NOTICE OF
ADDENDUM NO. 1

PROJECT NAME: Lift Station Renewal / Replacement Project – Consolidation of Buckingham, N. Post Oak Lane, & Stablewood Lift Stations

PROJECT NO: R-000267-109A-4

ADDENDUM NO. 1

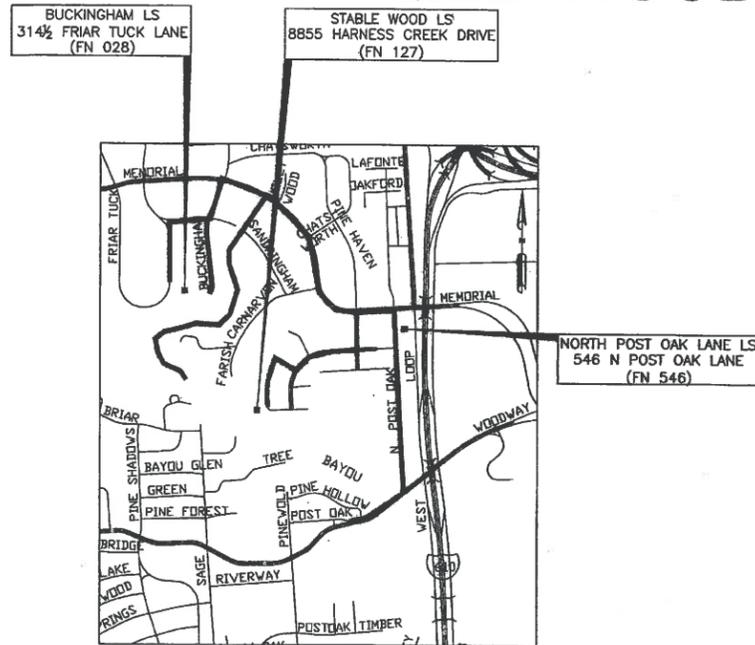
7. Plan Sheet G1 - "Cover Sheet" – Remove and replace this sheet in its entirety with attached Sheet G1 from Addendum No.1. Added HCFCF approval stamp.
8. Plan Sheet G5 - "General Notes" – Remove and replace this sheet in its entirety with attached Sheet G5 from Addendum No.1. Added HCFCF Notes and removed reference to night work.
9. Plan Sheet C5 – "Buckingham Sta. 0+00 to Sta. 4+00" – Remove and replace this sheet in its entirety with attached Sheet C5 from Addendum No. 1. Utility Signatures added to sheet.
10. Plan Sheet C15 – "E. Friar Tuck Sta. 0+00 to Sta. 4+00" – Remove and replace this sheet in its entirety with attached Sheet C15 from Addendum No.1. Utility Signatures added to sheet.
11. Plan Sheet C21 – "Memorial Sta. 5+00 to Sta. 10+00" – Remove and replace this sheet in its entirety with attached Sheet C21 from Addendum No. 1. Utility Signatures added to sheet.

PLAN
 BUCKINGHAM
 STA 0+00 TO STA 4+00
C5

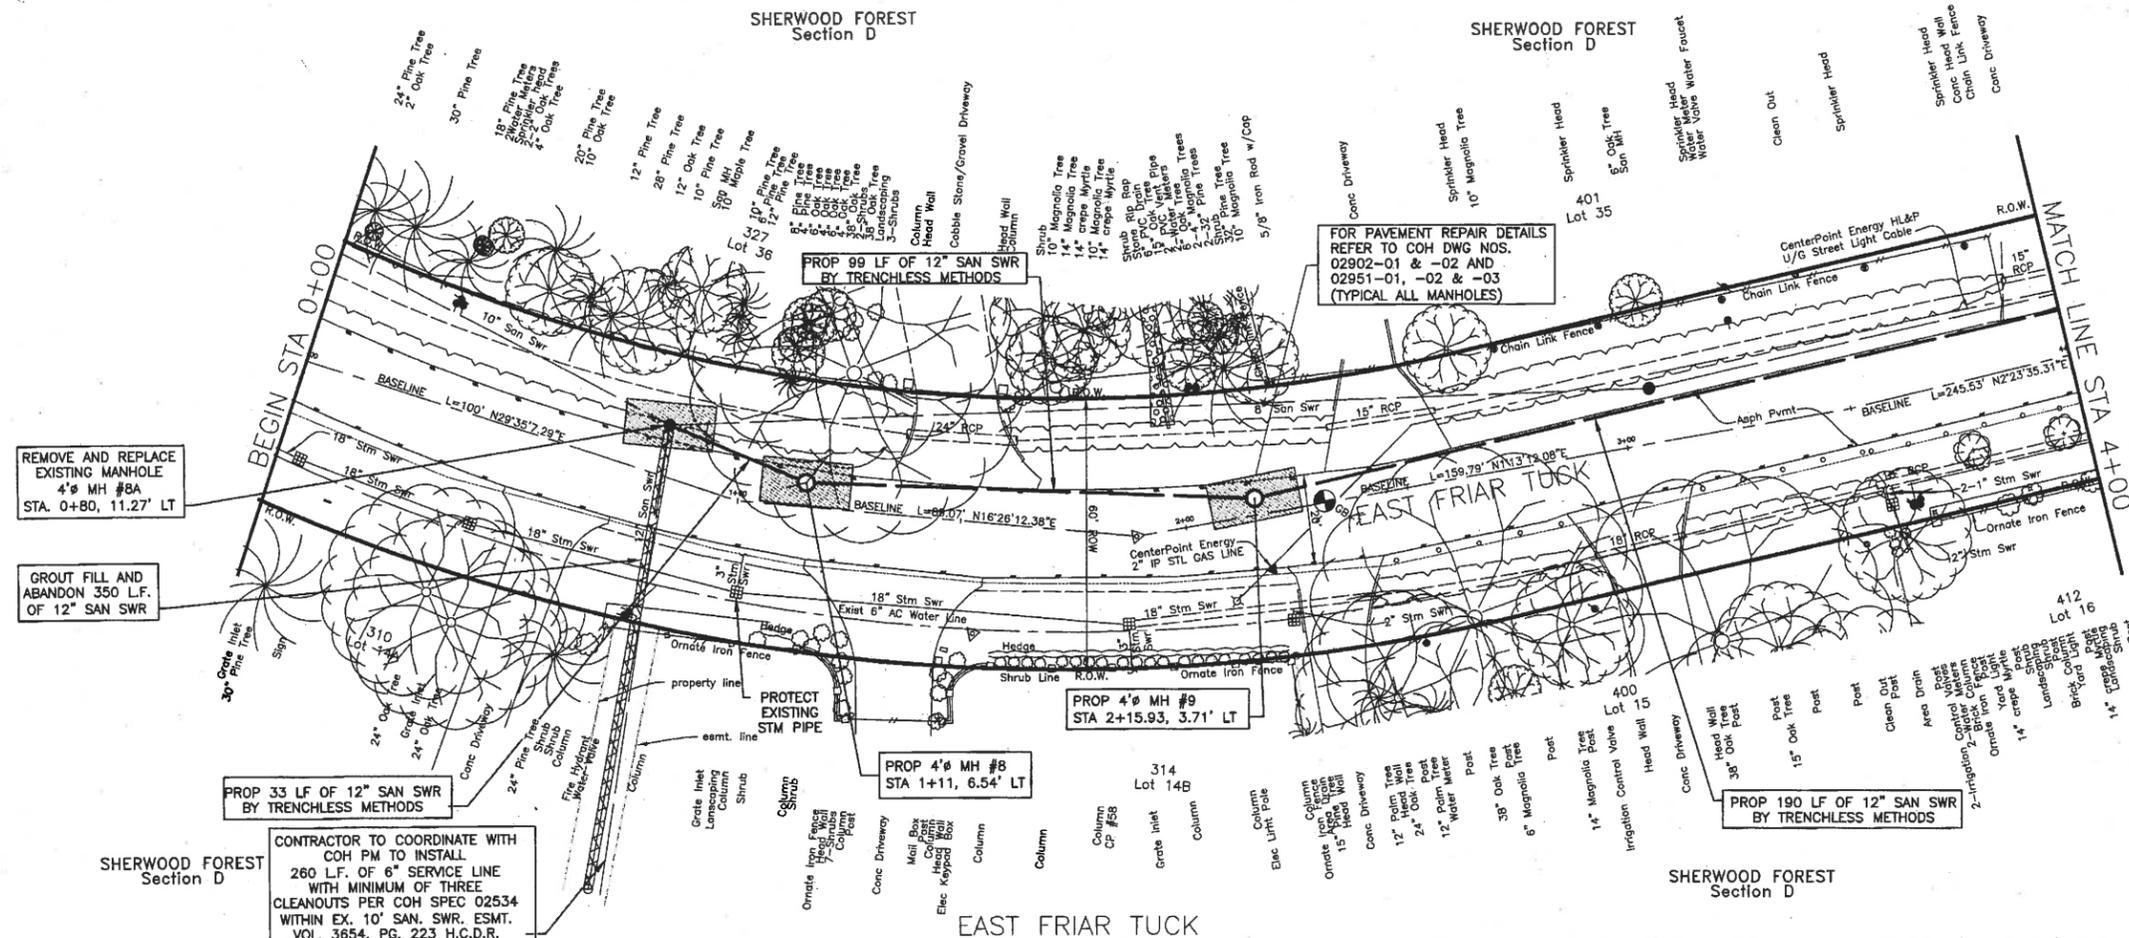
1	5/14/2015	UTILITY SIGNATURES	EQ
NO	DATE	REVISIONS	APP
PRIVATE UTILITY LINES SHOWN			
H. Malone		DATE: 5-5-15	
CenterPoint Energy/UNDERGROUND Electrical Facilities Verification ONLY (This signature verifies existing underground facilities - not to be used for contact verification.) Signature Valid for twelve months.			
D. Cantwell		DATE: 5-5-15	
AT&T TEXAS/SWBT UTILITY LINES SHOWN			
APPROVED AT&T TEXAS/SWBT FOR UNDERGROUND CONDUIT FACILITIES ONLY SIGNATURE VALID FOR ONE YEAR.			
H. Malone		DATE: 5-5-15	
CenterPoint Gas/Natural Gas Facilities Verification ONLY (This signature verifies that the line shown did indeed exist in the vicinity - not to be used for contact verification.) (Gas service lines are not shown.) Signature Valid for twelve months.

PLAN WOODWAY
 STA 34+40 TO STA 39+00

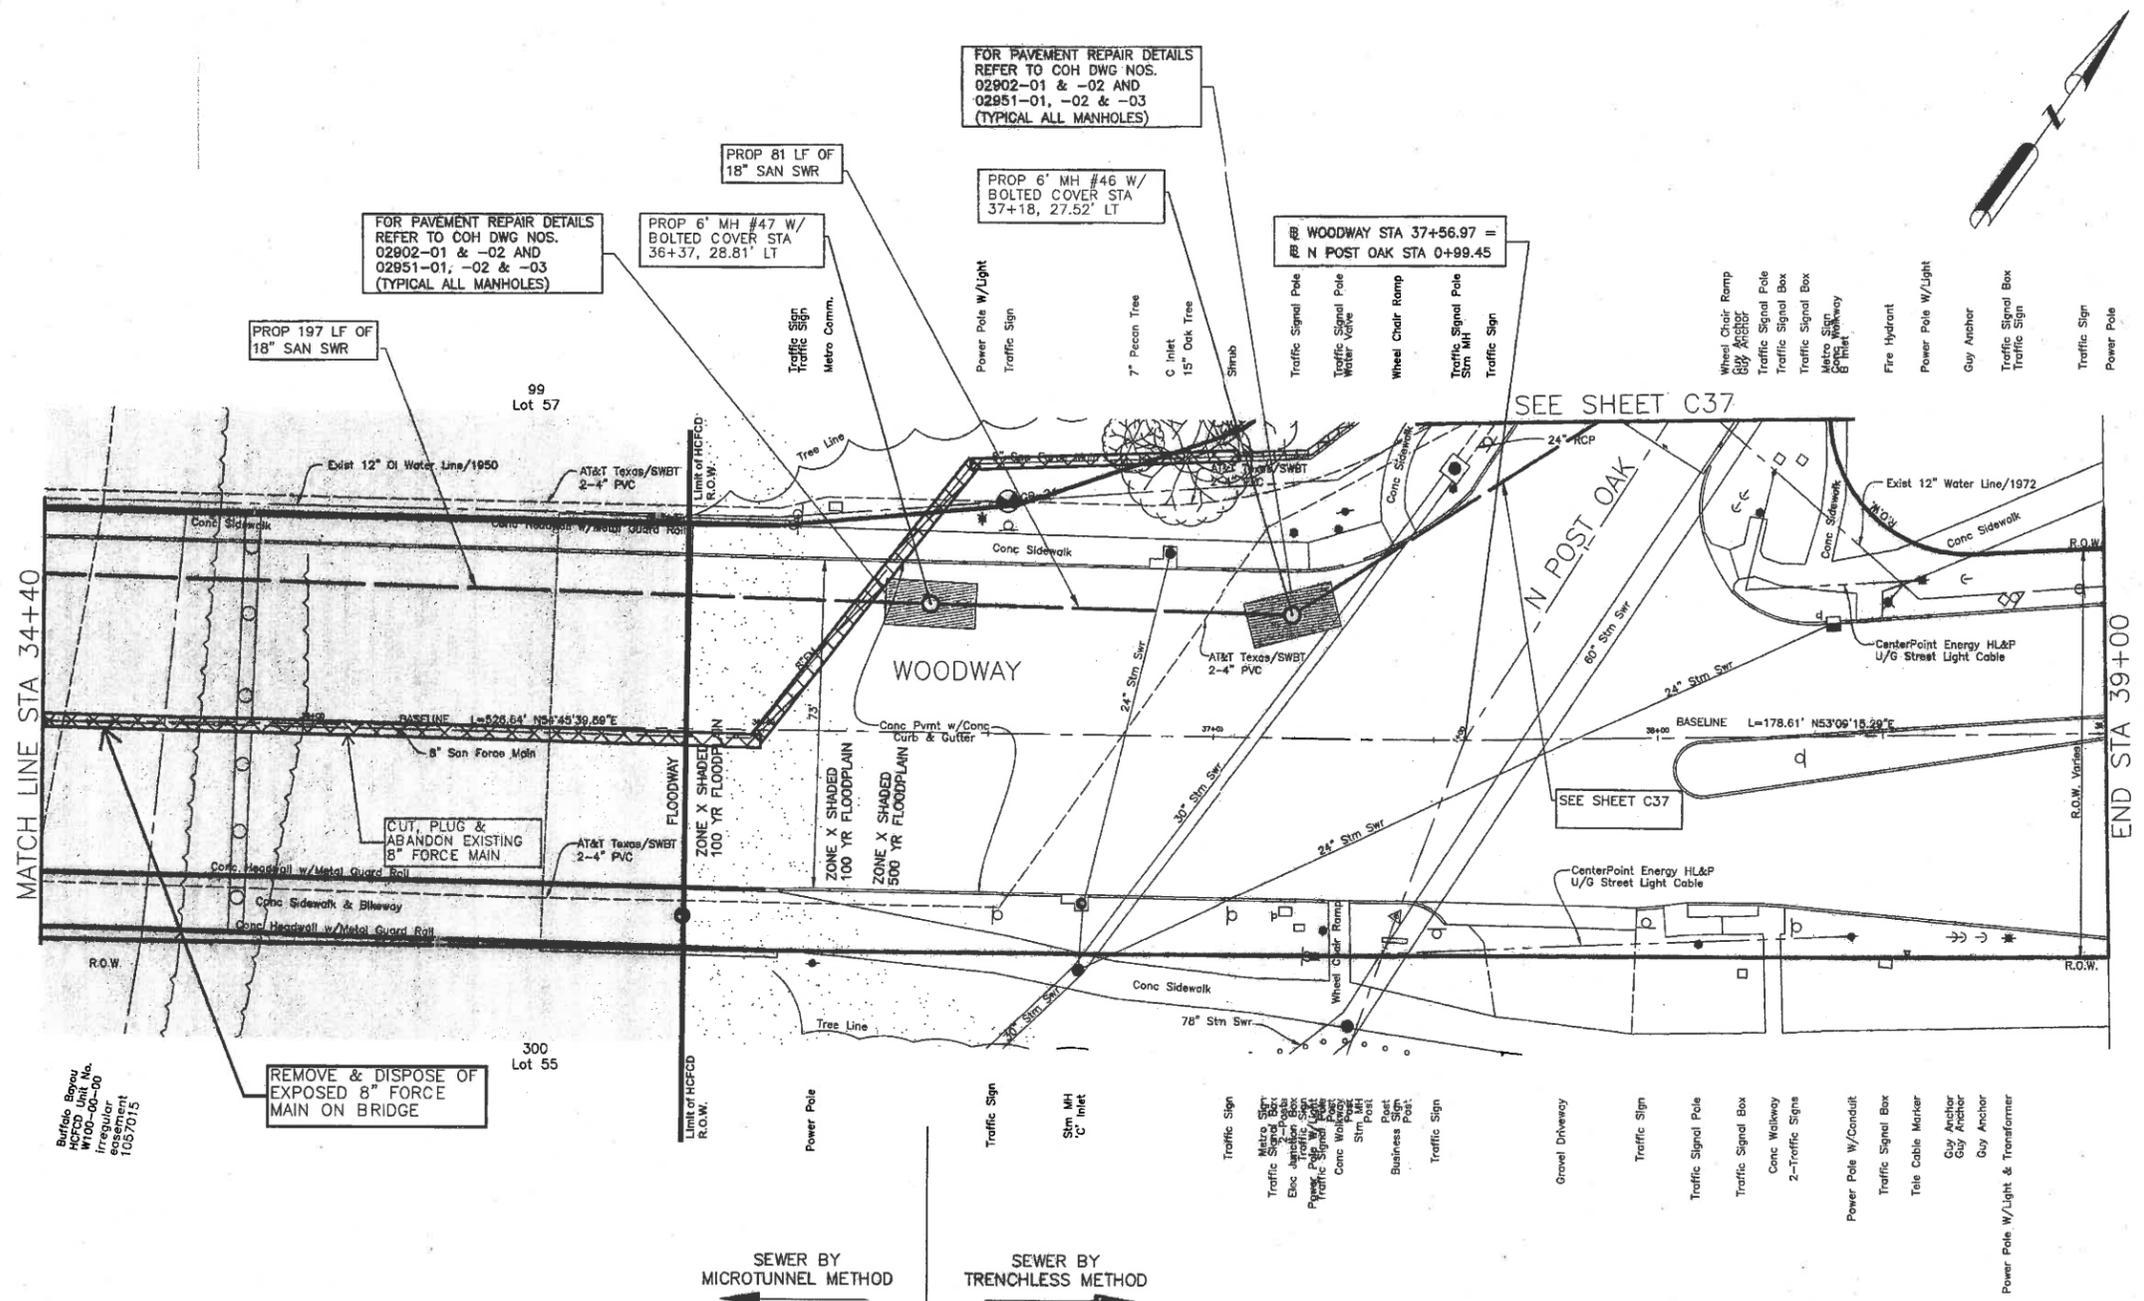
12. Plan Sheet C98 – “Woodway Sta. 29+40 to Sta. 34+40” – Remove and replace this sheet in its entirety with attached Sheet C98 from Addendum No. 1. Utility Signatures added to sheet.
13. Plan Sheet C101 – “Woodway Sta. 34+40 to Sta. 39+00” – Remove and replace this sheet in its entirety with attached Sheet C101 from Addendum No. 1. Utility Signatures added to sheet.
14. Delete Sheet TCP-3, “Traffic Control Plan Memorial Drive at N. Post Oak Lane” and replace with Plan Sheet TCP-3A from Addendum No. 1. References to Night work removed, two way traffic control for North Post Oak Lane added to this sheet, and traffic control for Memorial Drive added to this sheet.

TRAFFIC CONTROL PLAN
 MEMORIAL DRIVE
 AT N POST OAK LANE
 TCP3-A

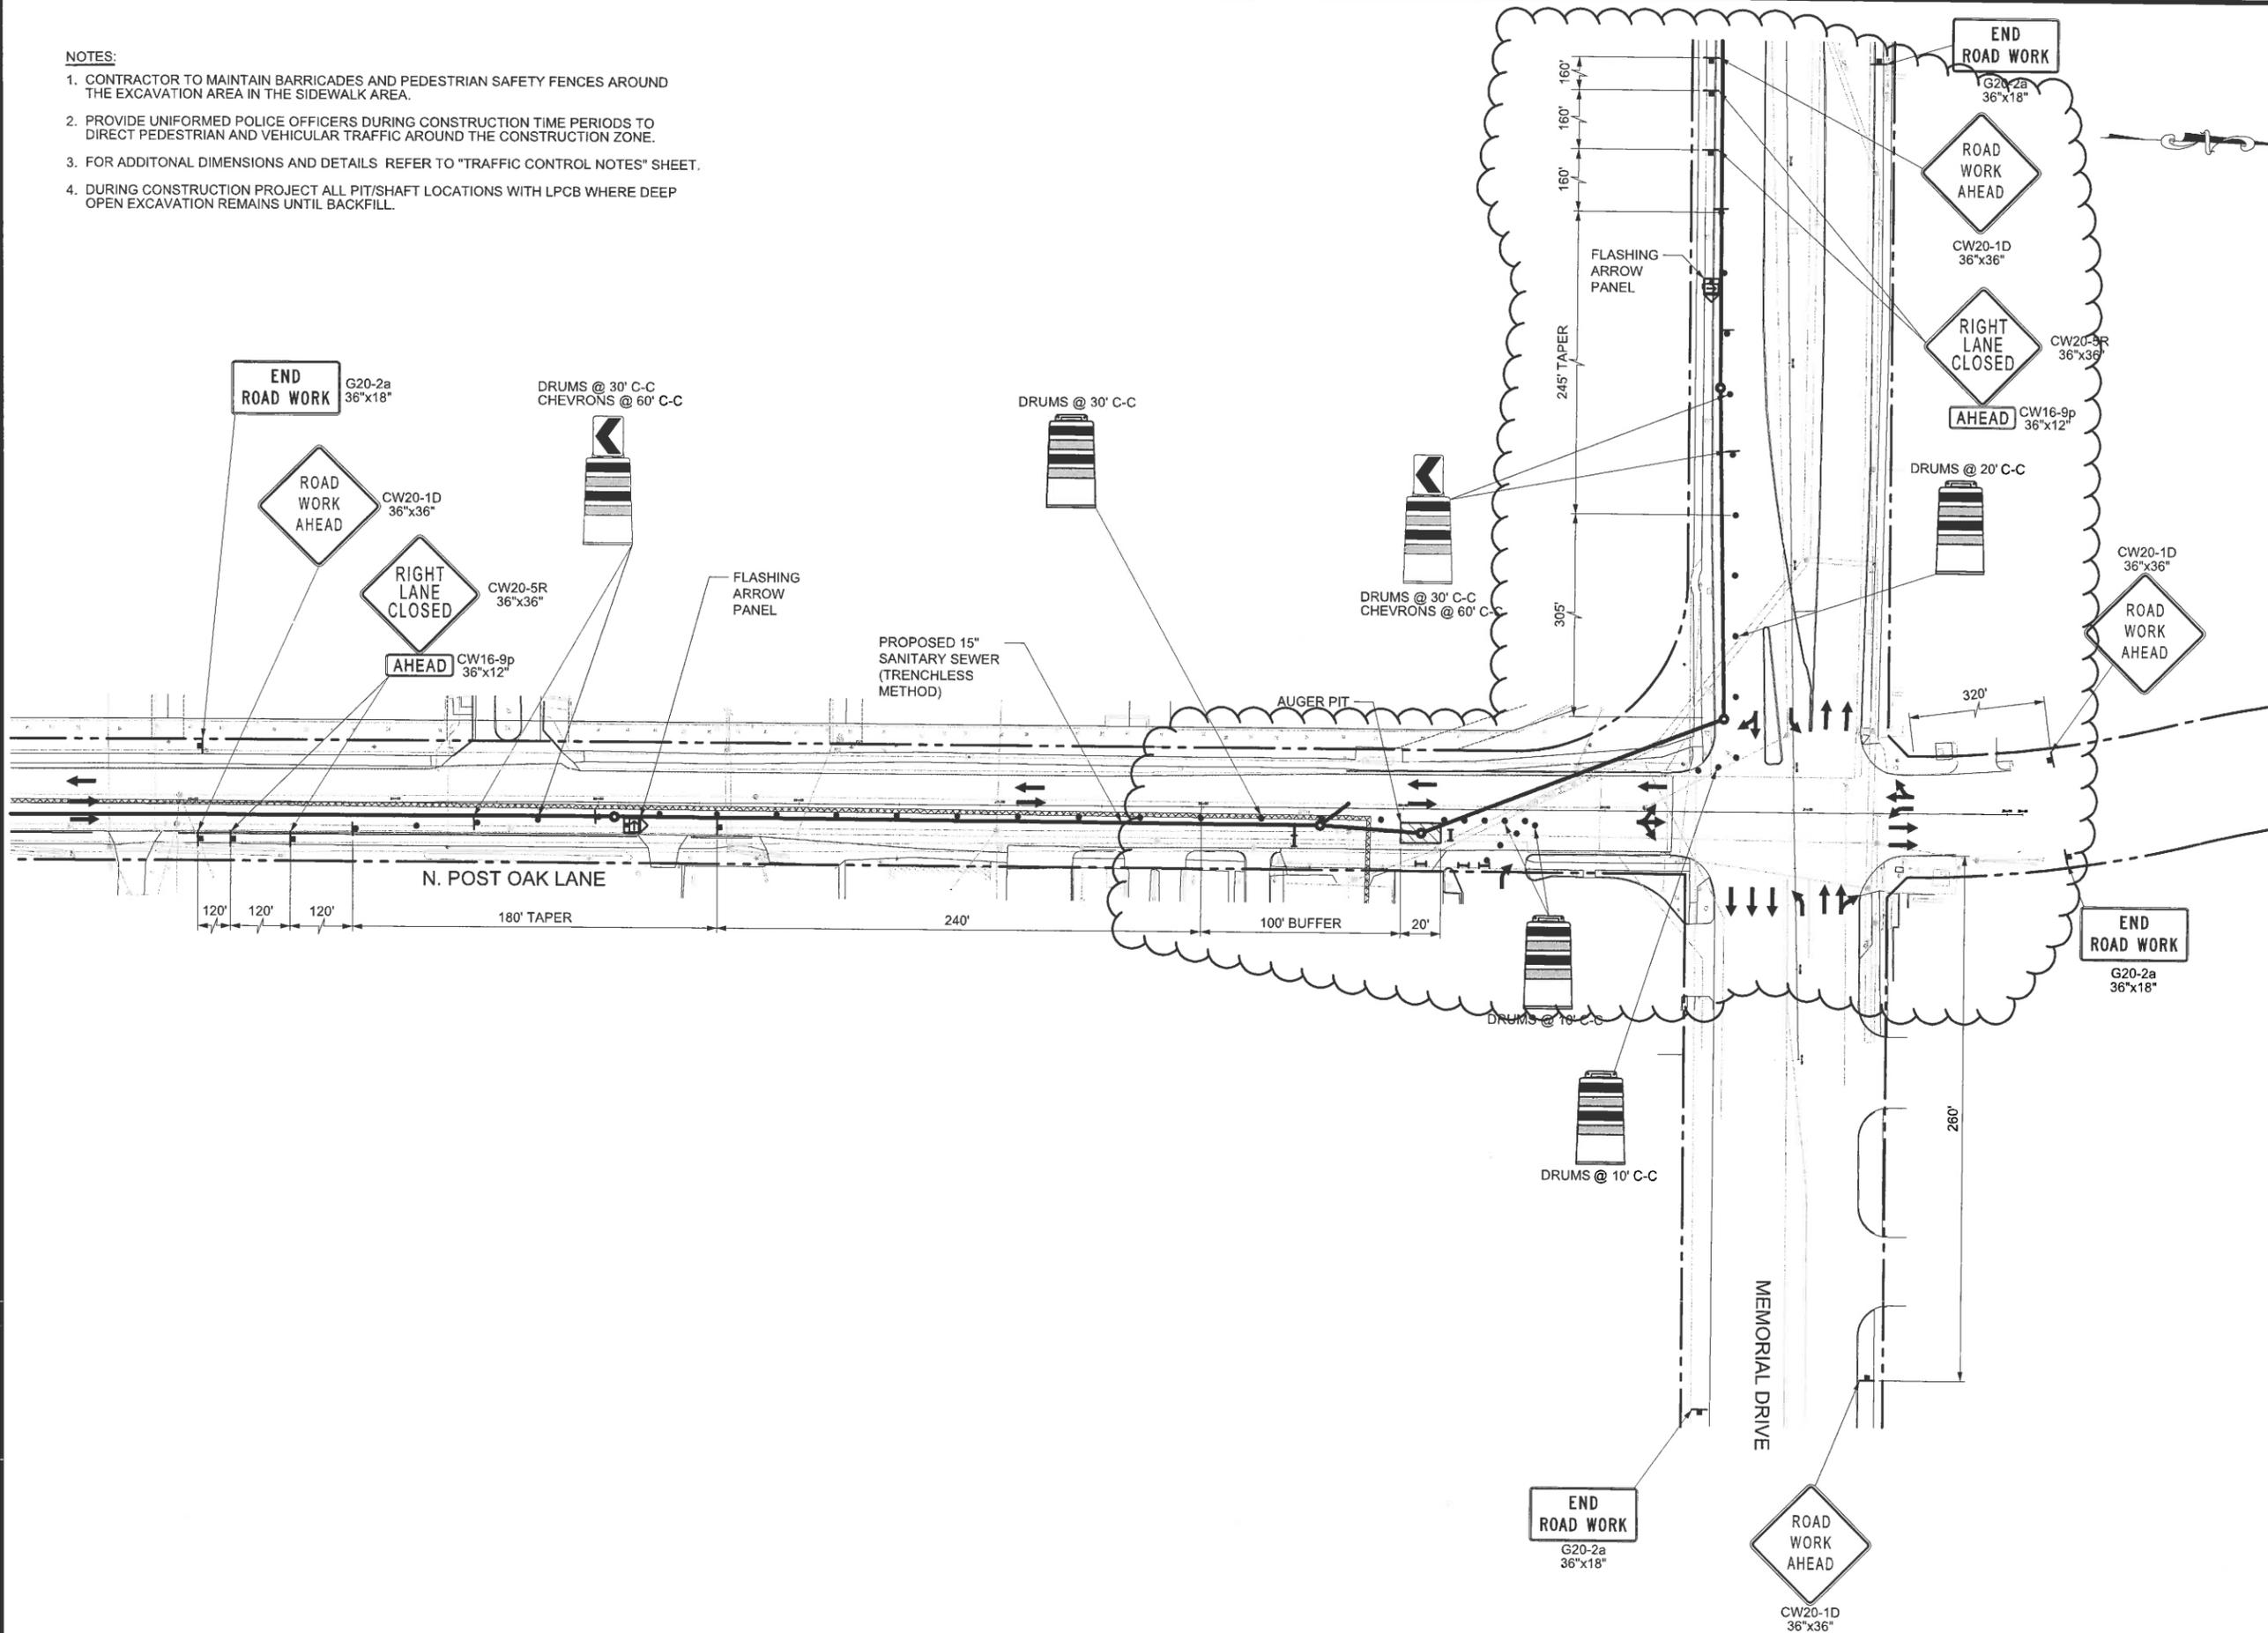
23. Question from Contractor: There appears to be no Traffic Control Plan for Memorial Drive similar to what is shown on Woodway and North Post Oak. There are typical details on TCP7-TCP9 that show Memorial Drive speed limit signs along with Note 4a, that restricts lane closures from 9:00 am to 4:00 pm. The 4400 LF of 15" – 12" S.sewer along Memorial with 13 manholes cannot be constructed under these conditions without adding approximately \$10,000,000.00 to the cost of the project. The need to dewater continuously during shaft and tunnel construction and the need for the shafts to project above the street level requires that detours be constructed around the shafts and the work progressed continuously. Will this be allowed?

Response: The restriction on lane closures has been eliminated. Furthermore, the Contractor will be required to obtain street cut and lane closure permits from the Street Cut Permit Section (SCPS); as such, the exact details of the Contractor's means and methods are addressed during this process. It should be noted, the Contractor's application is subject to approval by the SCPS. Likewise the

1. CONTRACTOR TO MAINTAIN BARRICADES AND PEDESTRIAN SAFETY FENCES AROUND THE EXCAVATION AREA IN THE SIDEWALK AREA.
2. PROVIDE UNIFORMED POLICE OFFICERS DURING CONSTRUCTION TIME PERIODS TO DIRECT PEDESTRIAN AND VEHICULAR TRAFFIC AROUND THE CONSTRUCTION ZONE.
3. FOR ADDITIONAL DIMENSIONS AND DETAILS REFER TO "TRAFFIC CONTROL NOTES" SHEET.
4. DURING CONSTRUCTION PROJECT ALL PIT/SHAFT LOCATIONS WITH LPCB WHERE DEEP OPEN EXCAVATION REMAINS UNTIL BACKFILL.
